APPENDIX C: MEETINGS & PUBLIC INVOLVEMENT

Planning Study Kickoff Meeting Continued – November 2022

Warroad International Memorial Airport
Agency Meeting – April 30, 2024

Taxiway and Terminal Alternatives Summary Table

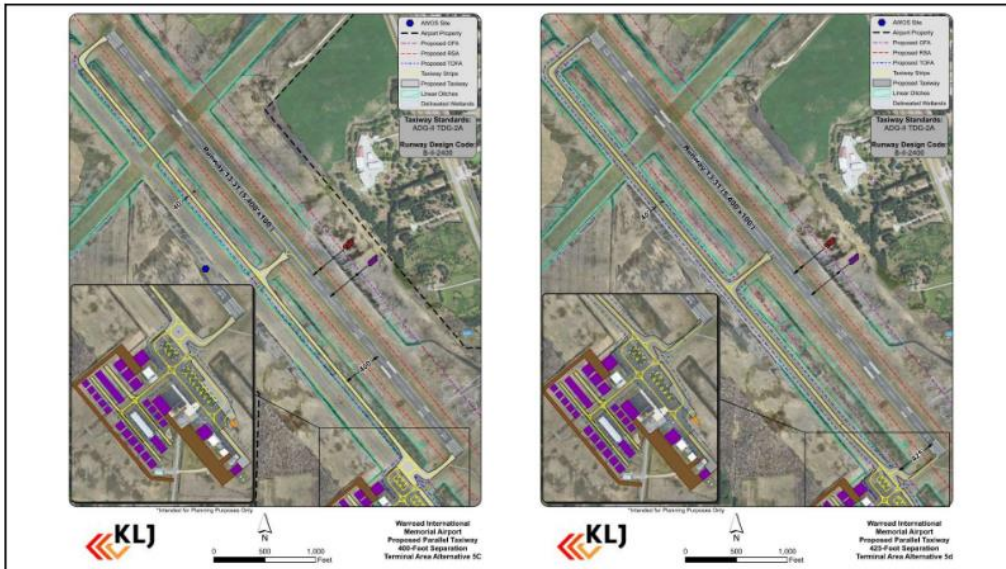
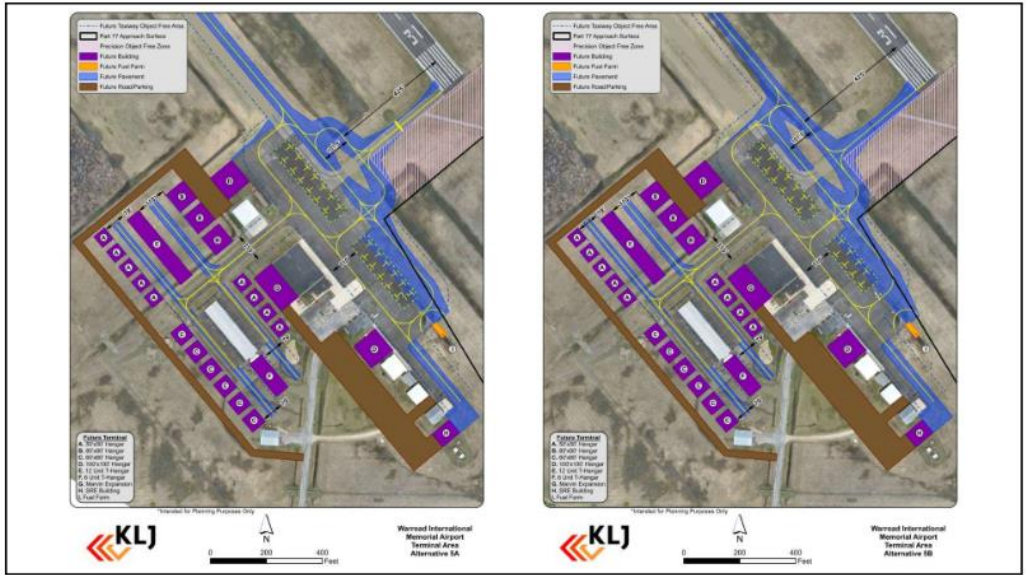
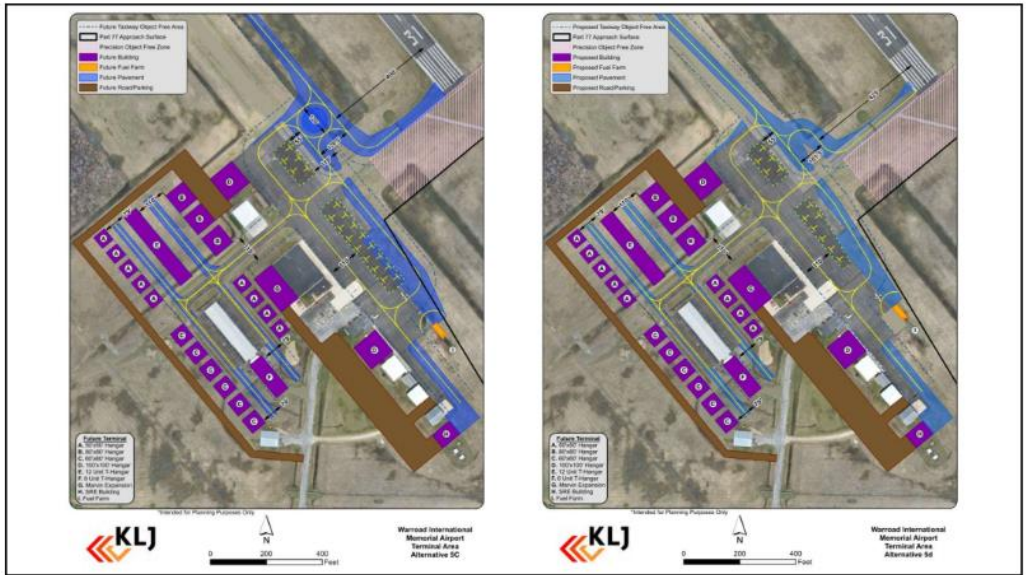
1. Reviewed Alternatives (5A, 5B, 5C, 5D) for parallel taxiway alignment and direct access to Runway 31.
 - a. Alternative 5A and 5D utilize existing taxiway minimizing wetland impacts while 5B and 5C have full length parallel at 425' and 400' separation. Airport prefers Alternative 5D for minimum development and least wetland impacts.
 - b. FAA does not support taxiway going through the POFZ. Being that the airport is not uncontrolled hold short marking would not be as effective.
 - c. Mellissa Jenny, FAA, noted that an EA would likely be triggered at a 3-acre threshold for wetland impacts (under Transportation Regional General Permit). Alternative 5A would be CATEX as it is below the 3-acre threshold.
 - d. FAA would participate up to a taxiway width of 35' for TDG-2A standards. Matt Lebens said MnDOT does not require 40' width for Key GA airports but generally supports 40' width.

- e. FAA requested phased development plan to show how direct runway access removal will be implemented with the taxiway and apron. Conflict resolution with aircraft movement should be evaluated in phased development with single runway access.

2. Reviewed Alternatives (5A, 5B, 5C, 5D) for apron area.
 - a. Alternatives 5A, 5B, and 5C have dual taxilanes layouts which penetrate the RPZ, Part 77 Approach Surface and MnDOT Clear Zone. Alternative 5D remains outside of these surfaces at the expense to available aircraft parking. The Airport prefers Alternative 5C.

- b. Watson, FAA, said using a reasonable tail height of critical aircraft, the sponsor needs to submit the preferred alternative through an airspace study for further evaluation for the Approach Surface penetration.

- c. FAA expects RPZ alternatives and evaluation as part of planning study narrative. Document issues such as proximity of parking to terminal, impacts to parking space operations by large aircraft (DNR). Land Use Compatibility AC provides prescriptive details on how RPZ alternatives should be evaluated.

1. KLJ will revise Preferred Alternative with Taxiway A1 shifted to 400' separation and submit for airspace study.

Preferred

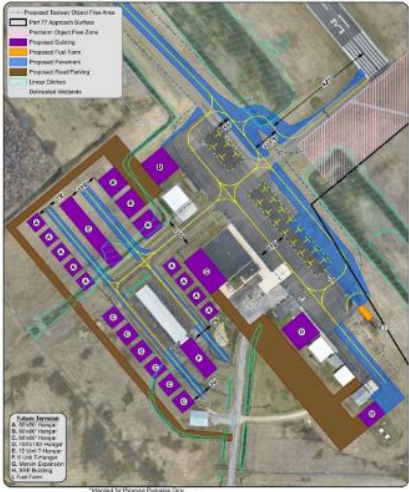
- Preliminary – Airport in discussion with users
- Combines taxiway and direct access from 5D with apron area of 5C
- Minimizes wetland impact and best utilization of apron pavement
